# BLOCK 56S - TOWER

401 8TH AVE N. RECOMMENDATION MEETING - ADR | DATE: NOVEMBER 20, 2020 | SDCI #3017379

ANKROM MOISAN ARCHITECTS // SITE WORKSHOP // VULCAN REAL ESTATE

Average Setback along Harrison St.  
Current Design: 23ft  
CURRENT DESIGN

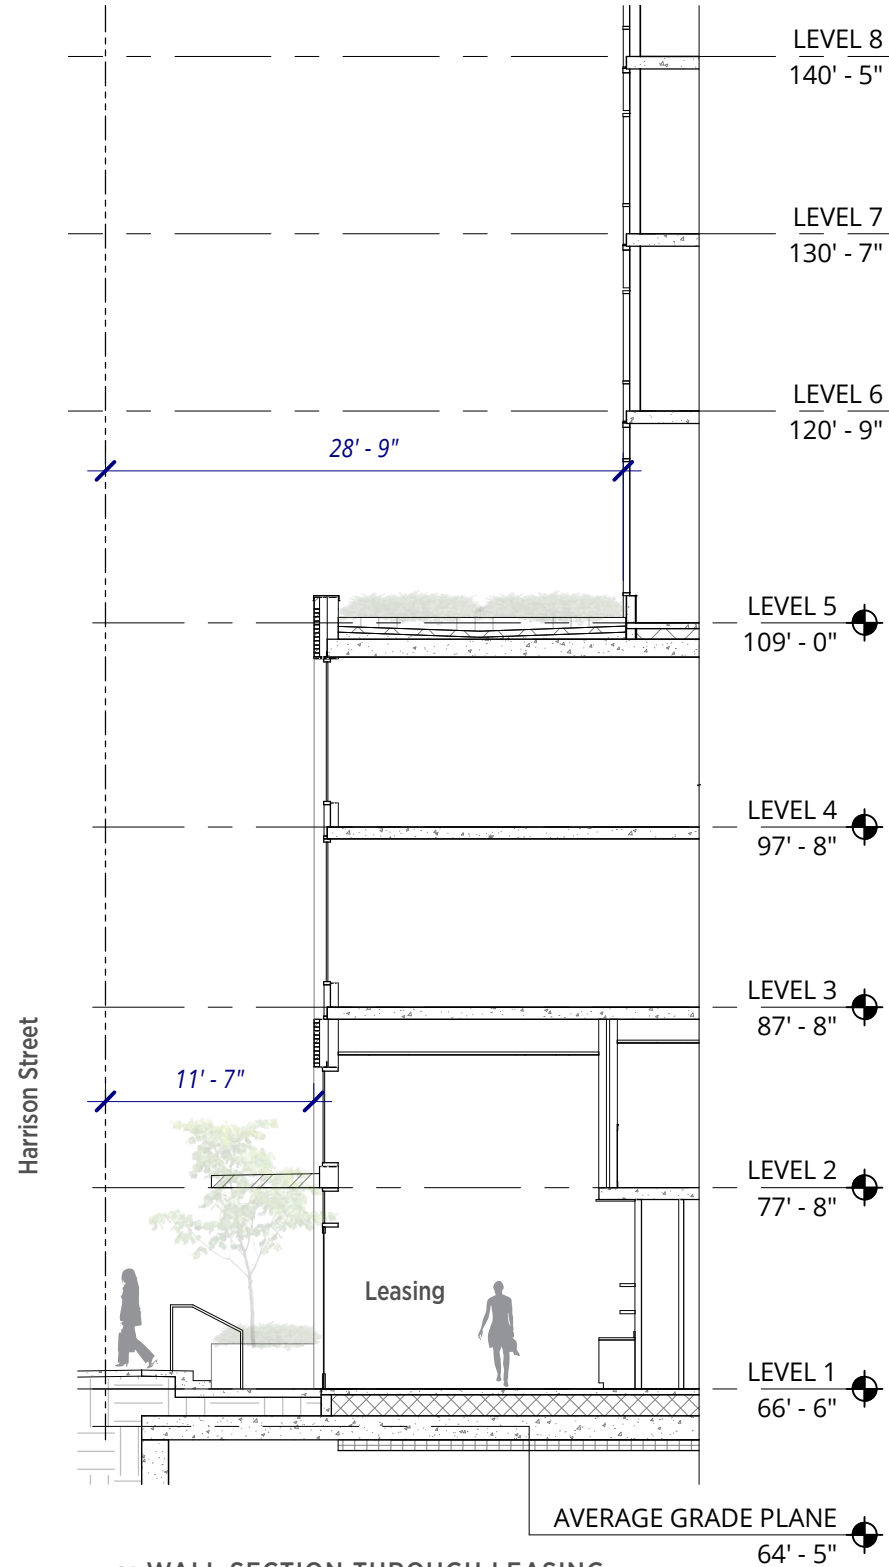
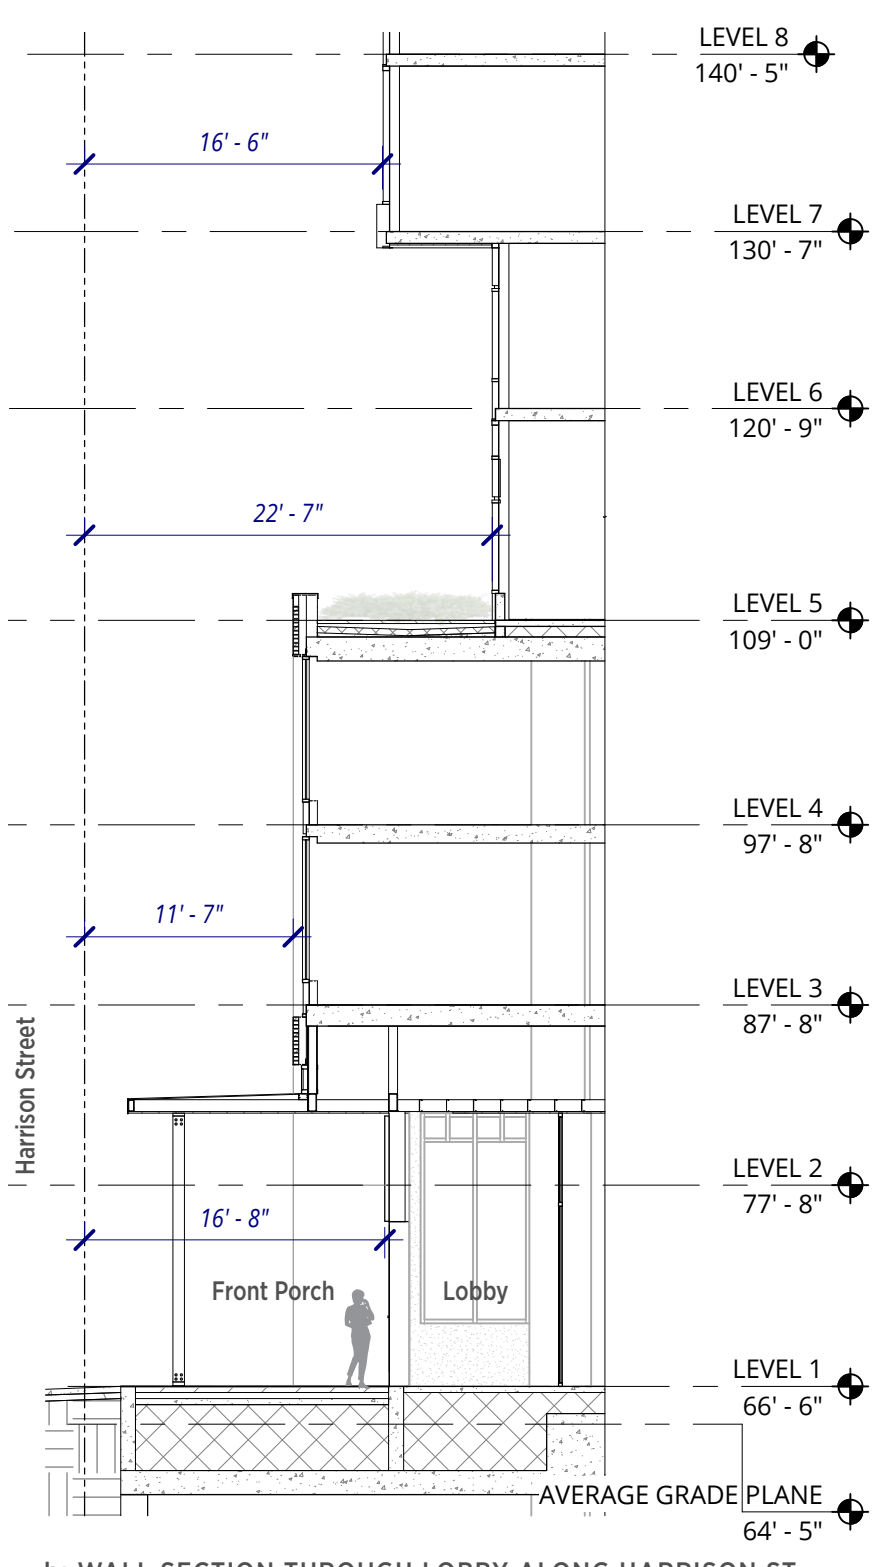
The Board agreed the tower facade should be well set back from the south property line (more than 10ft shown), to reinforce the pattern along Harrison Street where taller masses are typically set back to widen the "Neighborhood Heart" street experience. The ground level (and possibly floor 2) along Harrison should also be set back the approximate 10ft shown, to provide a generous ground level transition zone. The Board was open to the podium form between possibly being closer to the property line, as long as there is a continuous ground level setback and a legible 'gasket' between the podium and tower. Large scale and dimensioned sections of floors 1-8 on both streets are requested to verify these relationships.

BIKE STORAGE PLAN  
SCALE: 3/32" = 1'-0"

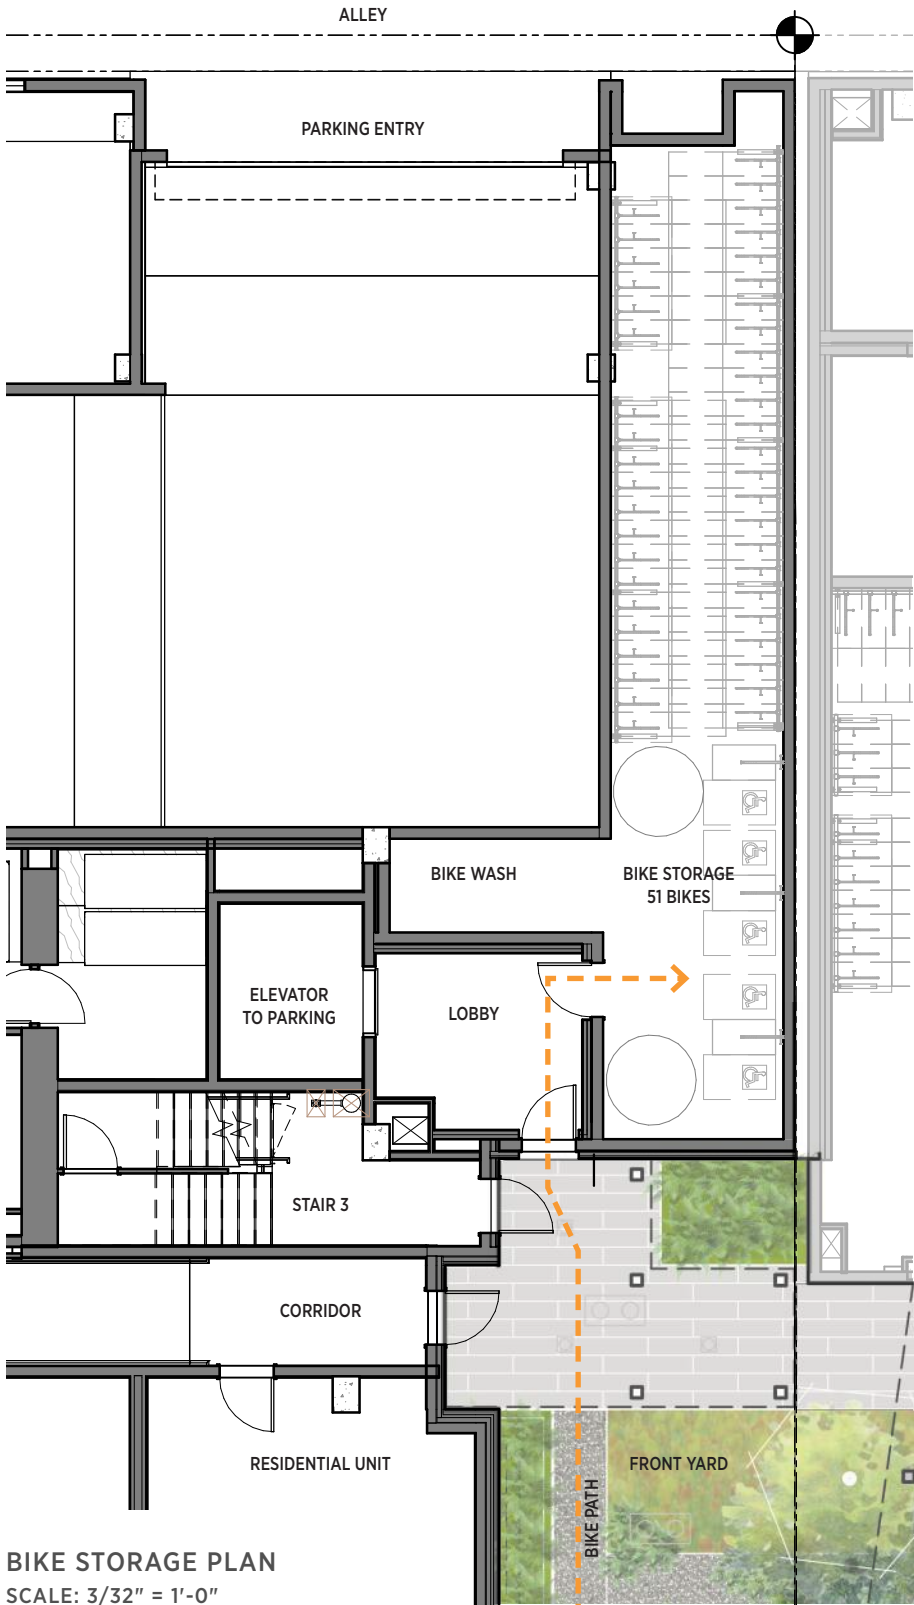
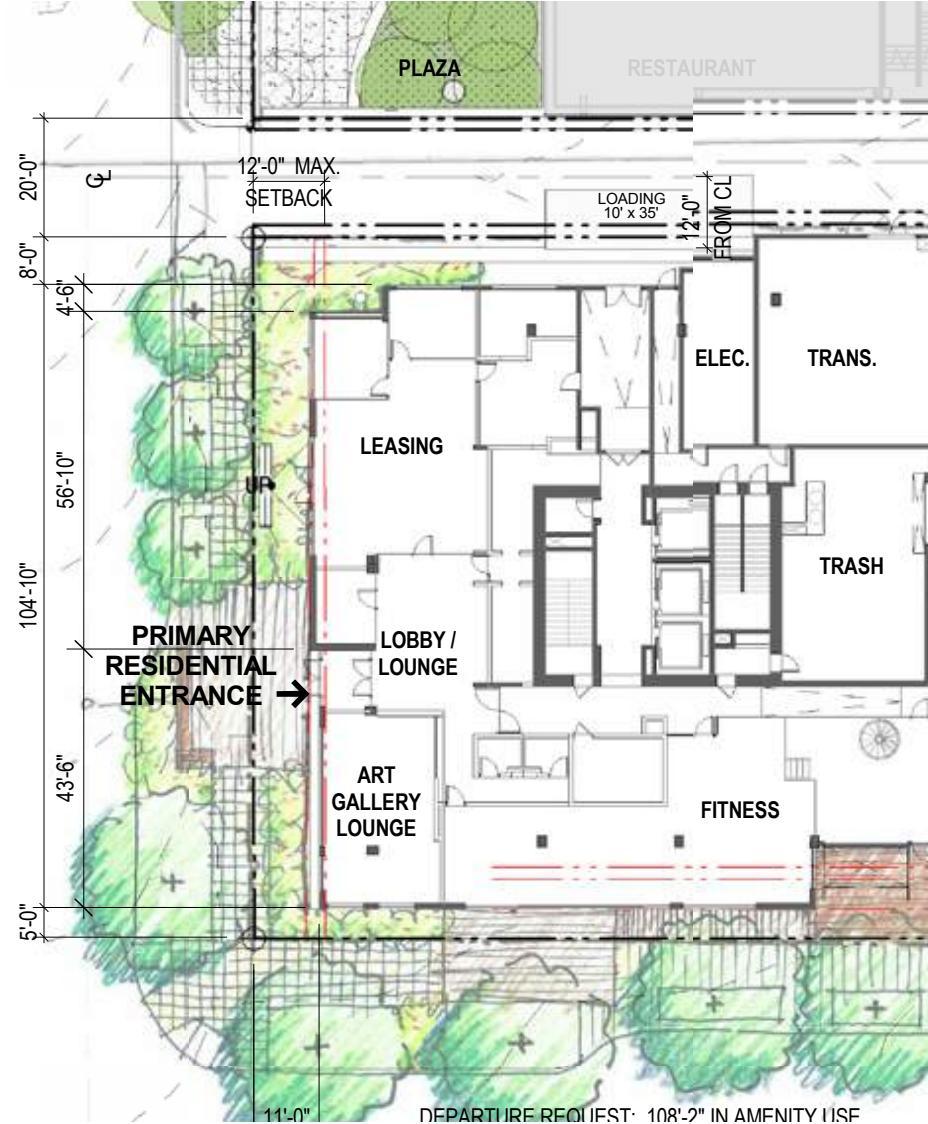
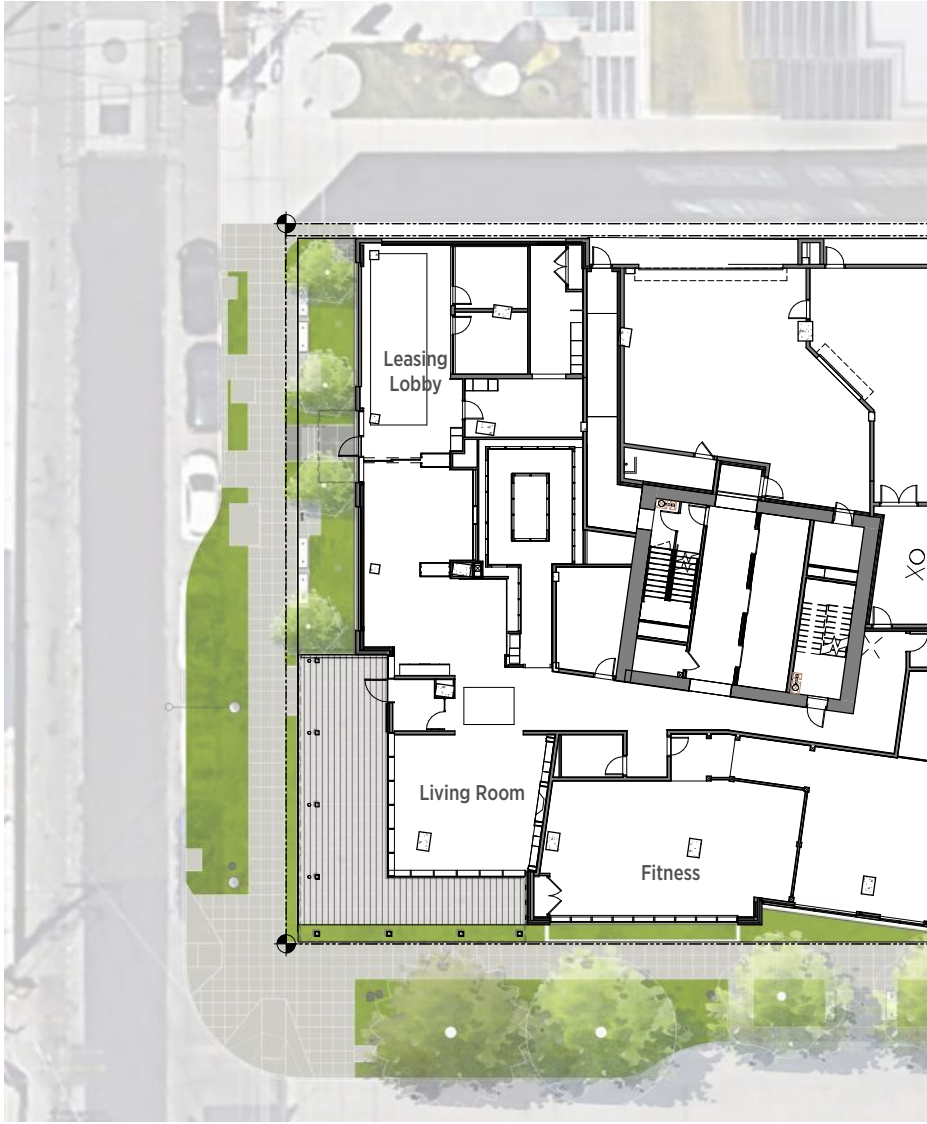
Since the alley may be congested at peak hours from the large adjacent office project, the Board advised exploration of a bike access corridor direct from 8th Avenue and/or Harrison Street, to the bike storage/ lockers (the plan on pg 46 appears to show the bike access about mid-block on the alley).

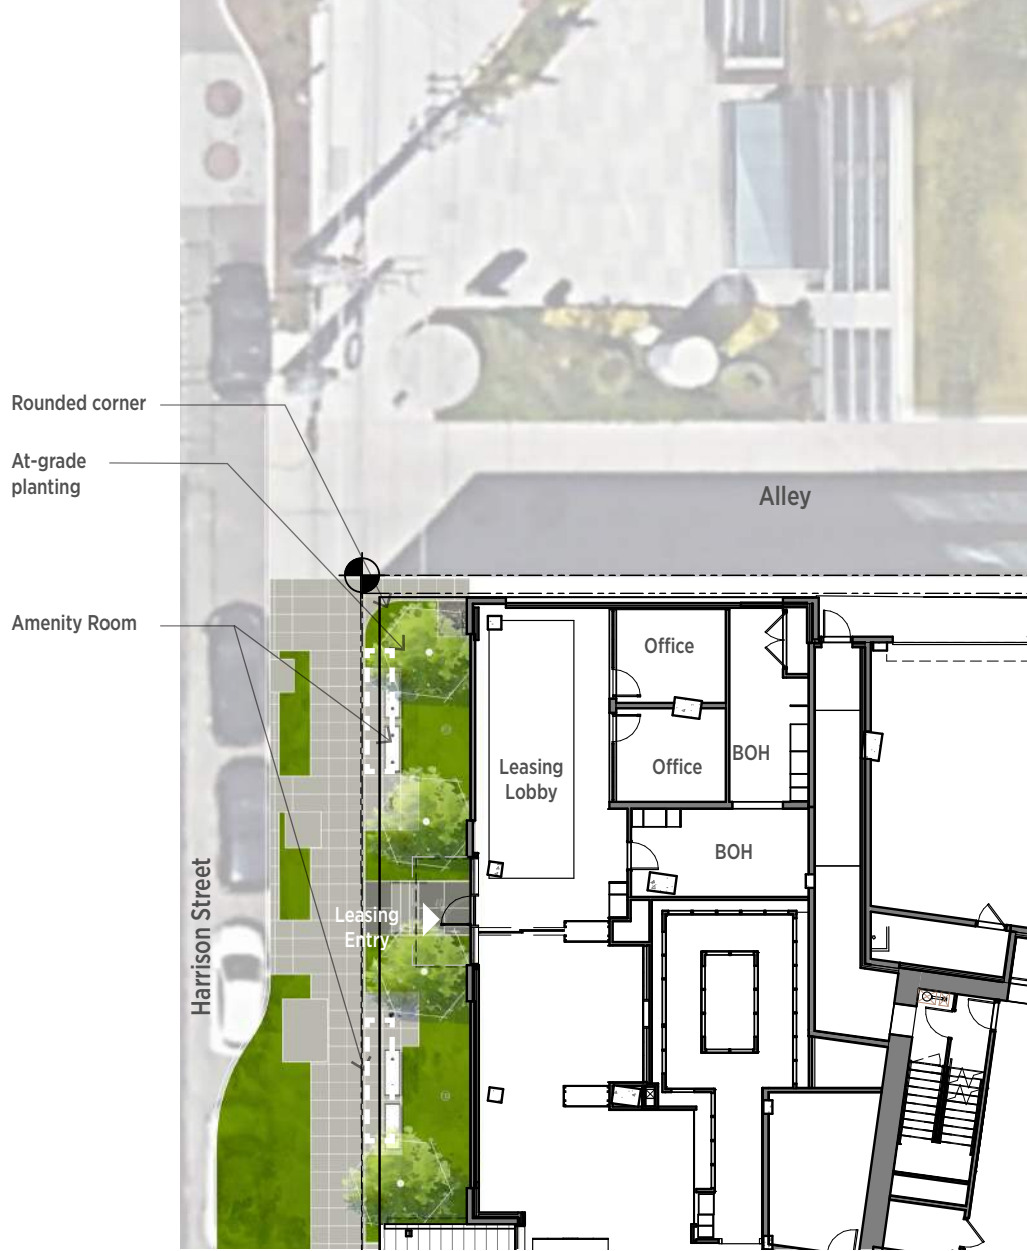
The Board did not support the narrow sidewalk and the depressed planter moat described for this corner, and encouraged a more creative, flush landscape and pedestrian design that fully responds to the adjacent plaza and pedestrian desire lines across the alley.

Based on verification of existing conditions, it appears that the design/layout of the adjacent plaza at 400 Dexter Ave N changed considerably between how it was presented on page 62 of the EDG presentation and eventual construction. While the earlier designs for this plaza proposed a generous pedestrian pathway to the alley (bisected by raised garage exhaust), the final design included a continuous raised planting bed parallel to the alley from the building face to the raised garage exhaust structure located at the south east property corner. This design change essentially eliminates the flowing nature of pedestrian flow encouraged by the previous design and create a more typical sidewalk/alley transition condition. The updated design proposes to mirror the adjacent condition with a widened sidewalk at the alley transition and radiused corner as a nod to the arcs and circular forms prevalent across the alley. Sidewalk width (6ft min.) is consistent with 400 Dexter Ave N. and the recently completed Arbor Blocks project across Harrison Street. Planting is proposed to be at sidewalk grade or raised, thereby eliminating the 'sunken moat' condition.

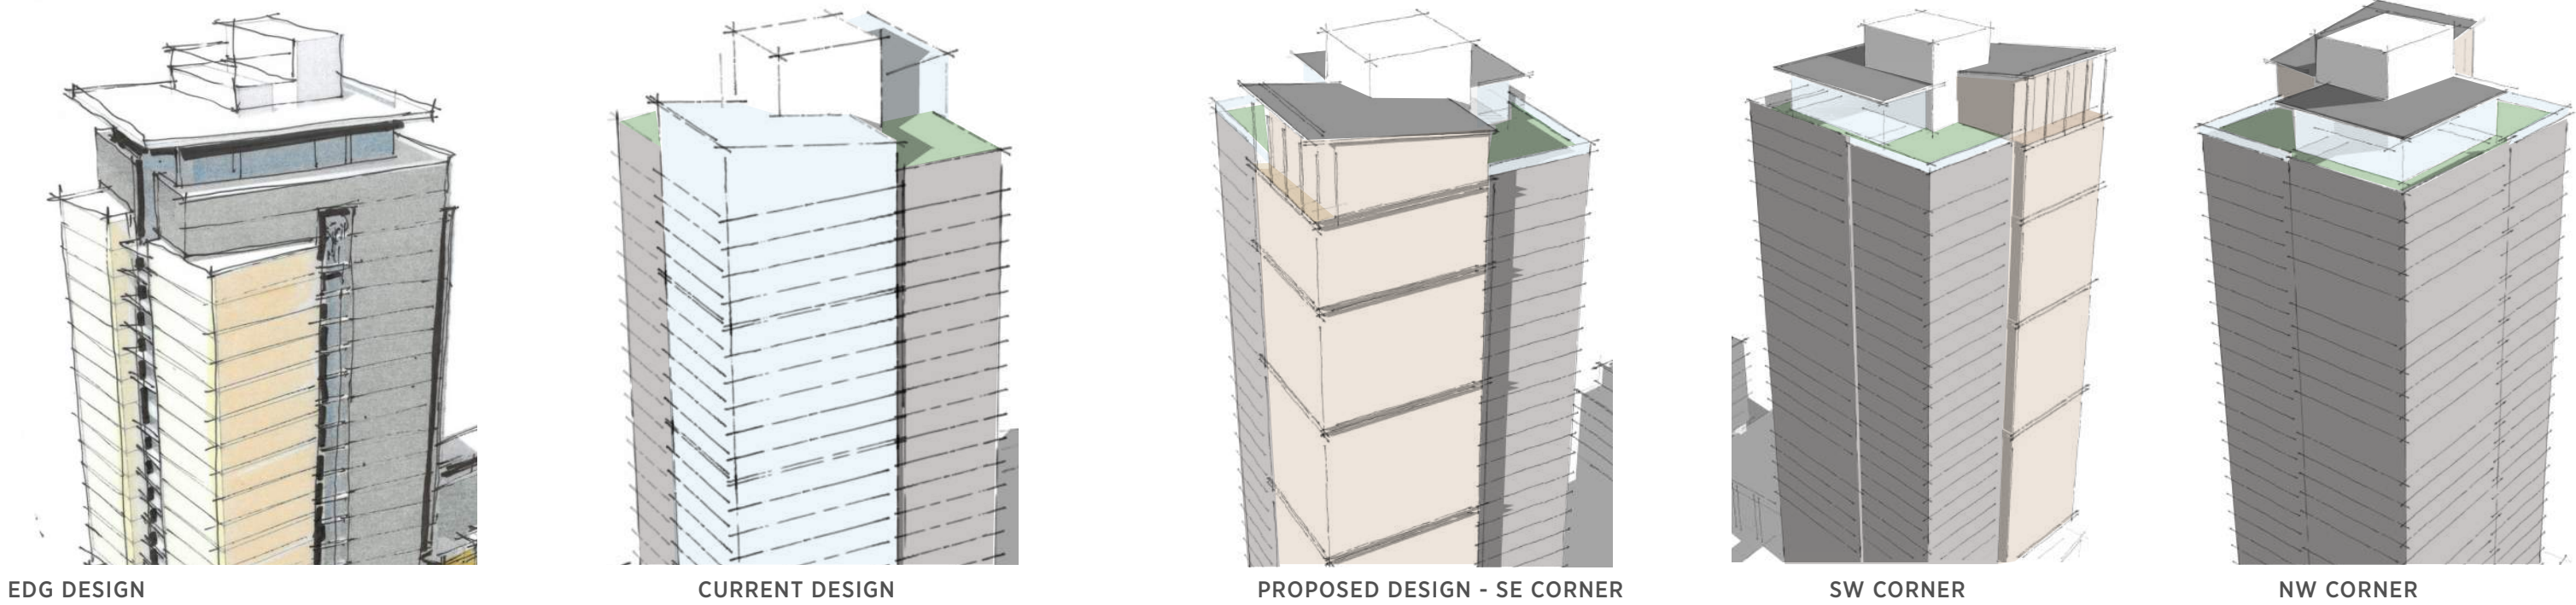
The roof's lack of distinctive form or character, both the 'whole' and the tower elements relative to each other.

The project team has revised the roof top to create distinctive treatments at the angled massing and the dark massing. The angled portion has been revised to create deep roof overhang along the south facade, creating a porch like space. The NW corner of the rooftop amenity has been pulled away from the roof edge in effort to strengthen the overall massing hierarchy, and becomes a roof top "pavillion" similar to EDG design.
